Public Meeting Under the Planning Act Meeting Agenda

Information Report – Draft Plan of Subdivision, Official Plan Amendment and Zoning By-law Amendment Application (26T19-02-18; OP-AM-03-18; & AM-04-18)

The purpose of this report is to provide Committee and the public with information regarding an application for Official Plan Amendment, Zoning By-law Amendment and Draft Plan of Subdivision under Sections 22, 34 and 51 (respectively), of the Planning Act for 162 Port Robinson Road.

File Numbers: 26T19-02-18 (Draft Plan of Subdivision)
OP-AM-03-18 (Official Plan Amendment)
AM-04-18 (Zoning By-law Amendment)

PRELIMINARY
DRAFT PLAN OF
SUBDIVISION

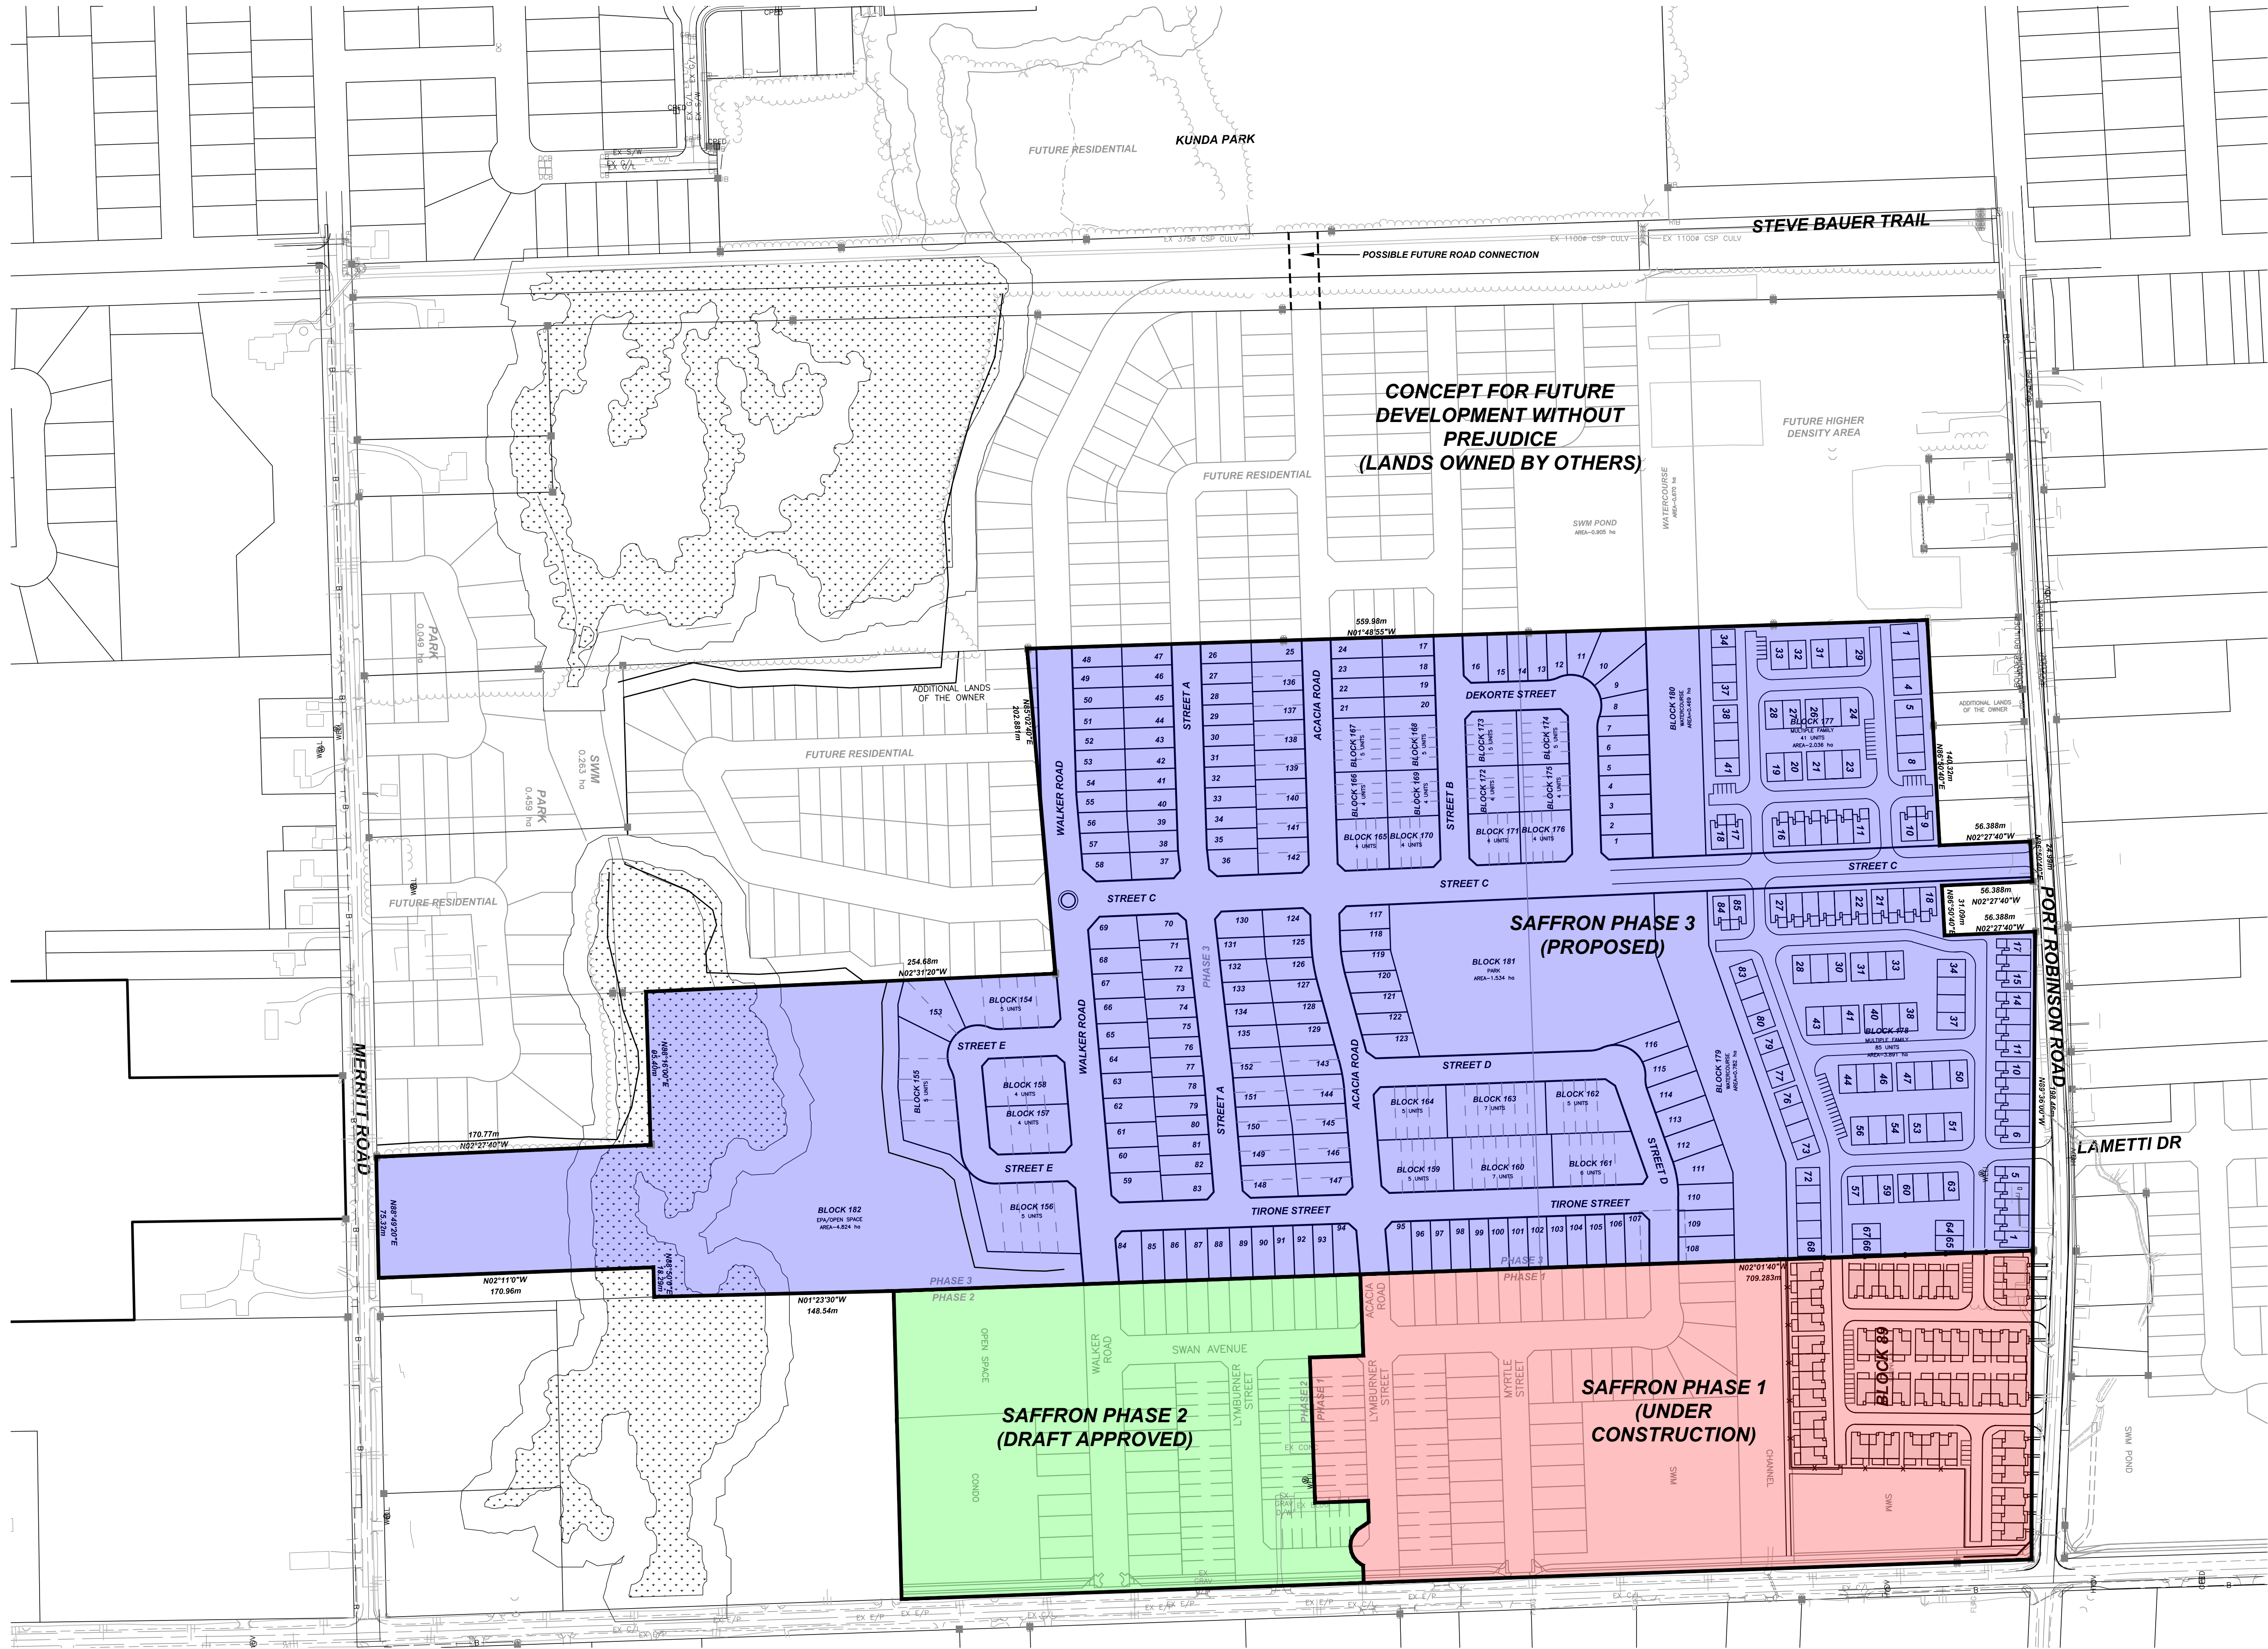
1. None of the block numbers or land areas listed in the 1st and 2nd paragraphs of Page 25 of Section 5 are consistent with those indicated in the Draft Plan of Subdivision – Drawing No. 1541-DP, except for the area indicated for the southern portion of the subject lands supporting EP1 and PSW. Please revise accordingly.
2. The 3rd sentence of Section 6.1.1 state that Block 146 through 149 will lie adjacent to the EP1 forest edge. According to the Draft Plan of Subdivision, Drawing No. 1541-DP, it will be development blocks 153 through 156. Please revise accordingly.

1. The 1st page indicates 128 proposed single detached dwellings; the Draft Plan of Subdivision indicates 135. Please revise accordingly.
2. In the 2nd sentence of the 2nd paragraph under 'Sanitary Servicing', it references Block 170 & 171. This appears to be incorrect as the two condominium blocks are Blocks 177 & 178.
3. The paragraph on Page 3 under 'Stormwater Management' is somewhat unclear. Based on a review of the drawing entitled 'Overall Storm Drainage Areas', it appears that storm sewer flow and overland flows from the portion of the proposed development south of the realigned channel will be conveyed to the South SWMF while storm sewer flow and overland flows from the portion of the proposed development north of the realigned channel will be conveyed to the North SWMF. Please confirm.

- b. The 3rd sentence of Section 6.1.1 on Page 26 of the study states that Block 146 through 149 will lie adjacent to the EP1 forest edge. According to the Draft Plan of Subdivision, drawing 1514-DP, it will be development blocks 153 through 156. Please revise accordingly.

- c. The 1st sentence of Section 6.2.1 on Page 27 of the study states that Block 146 through 149 will require permanent fencing with no gate along the rear lot lines. According to the Draft Plan of Subdivision, drawing 1541-DP, it will be development blocks 153 through 156. Please revise.

- d. On Pages 28-32 of the study, under multiple sections the study references Block 175 as the EPA/open space adjacent to the woodlot. According to the Draft Plan of Subdivision, drawing 1514-DP, Block 175 will be 4 unit towns and Block 182 will be the EPA/open space. Please clarify and revise all sections.

- a. In the table entitled 'Assumptions to Generate Development Yields – March 2012' of Appendix D of the Town's Official Plan, it lists 2.8 persons per unit as the household size to be assumed for semi-detached units. On the Draft Plan of Subdivision Dwg 1541-DP, the Consultant indicates a household size of 2.5 persons per unit for semi-detached dwellings. Please comment.

DRAWING TITLE	DATE	NOVEMBER 23, 2015
NEIGHBOURHOOD	PRINTED	NOVEMBER 26, 2015
MASTER PLAN	SCALE	1:2000
NEIGHBOURHOODS	DATE	NOVEMBER 26, 2015
(EAST FORTMILL SECONDARY PLAN)	REV	0

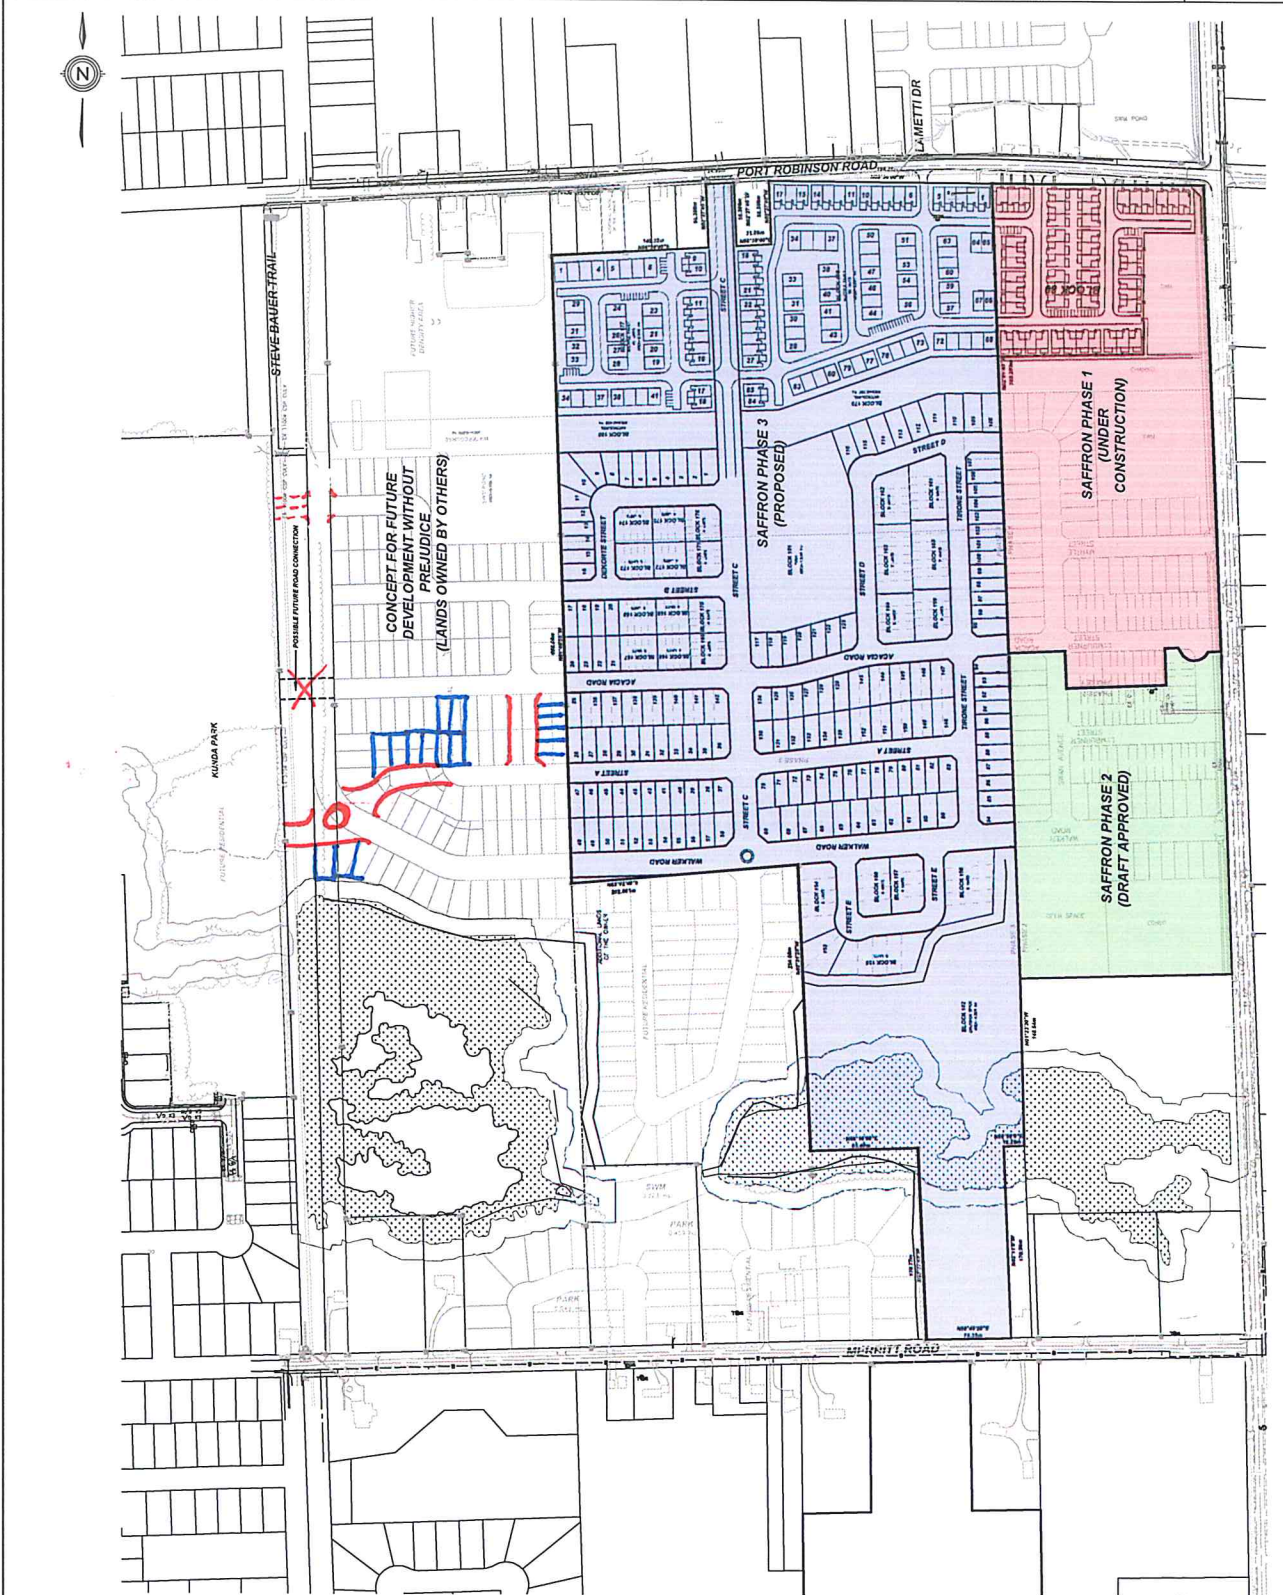
- Thank you for submitting the conceptual Neighbourhood Master Plan to illustrate how the lands to the west could interact with the subject lands and beyond.
 - Previously we asked for a street connection to be shown over the Steve Bauer Trail, at the time, we did not have access to the revised Kunda Park Phase 4 subdivision proposal, which proposes a SWM pond in the vicinity of an Acacia Road extension. Knowing this, and after more thought, Town staff believe the more logical connection(s) are with the Walker Road collector. (Attached)

- See Town Planning Comment #1
- Each development lot in a block must have frontage on a public road or laneway.
 - Though Blocks 177 & 178 are proposed to both have frontage on Street C, the land consumed by such large, future draft plans of condominium will need to be cognizant of where otherwise logical public road connections would have otherwise been located. The design must also be considerate of neighbouring lands which may, (or have been) developed by ensuring transportation connections and integration with the overall neighbourhood.

- The revised Neighbourhood Master Plan did not take into consideration the lands fronting on Port Robinson Road (west of Street C & one lot east of Street C).

The plans illustrate a potential street layout and lot patterning on adjacent lands to the west; however, ignore the potential redevelopment of lands lying north that are designated Medium Residential Density. More importantly, they do not contain the level of detail required by subsections B1.7.7.2 d), e) and f) above for a Neighbourhood Master Plan.

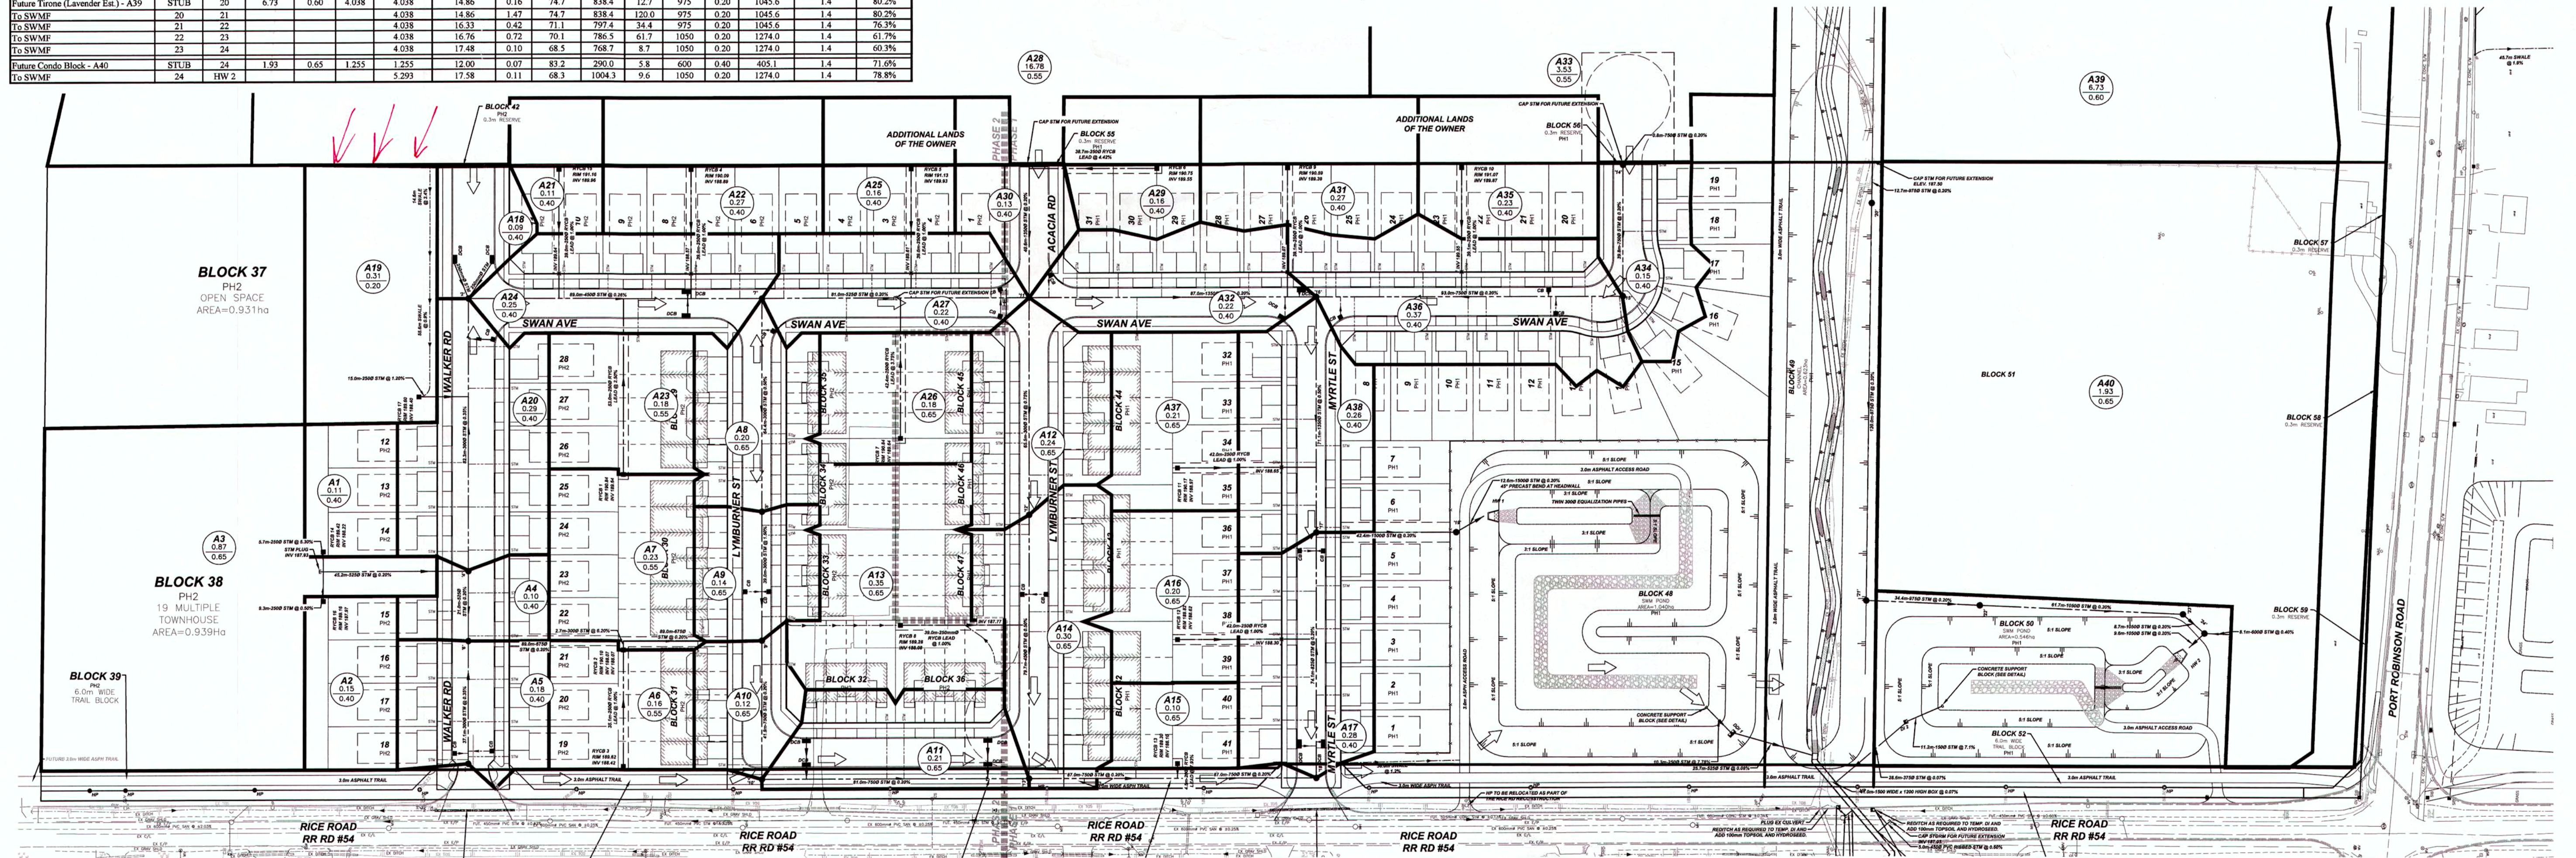
- a. The 3rd paragraph on Page 4 of the document under 'Stormwater Management' states that the receiving phase 1 and 2 of Saffron Meadows storm sewers flow at a maximum of 63.5% full. However, according to the design sheet on Phase 3 Storm Drainage Areas, drawing 1541-STMDA, there are multiple areas in phase 1 and 2 over this maximum. Including drainage area 13 running at 105.9% full. Please comment.
- b. The report is not signed. Please revise accordingly and ensure it is signed.

- a. In multiple drainage areas where townhouses are majority of the area, a run-off co-efficient of 0.55 was used when a co-efficient of 0.65, in accordance with the Town's Engineering Design standards, shall be used. Please comment and revise.
- b. The areas contributing to the South pond on the design sheets between Phase 3 DWG 1541-STMDA, Phase1&2 DWG 0478-STMDA and the Functional Servicing Report do not match. Please see attached PDF red-lines and comment.

A preliminary stormwater drainage area plan and design sheet have been included with this submission (DWG 1541-STMDA) to demonstrating how stormwater flows within site are to be conveyed and the available capacity in the existing storm sewers. The included design sheet shows that the receiving phase 1 and 2 storm sewers flow at a maximum of 63.5% full, therefore, there is adequate capacity in the receiving storm sewers.
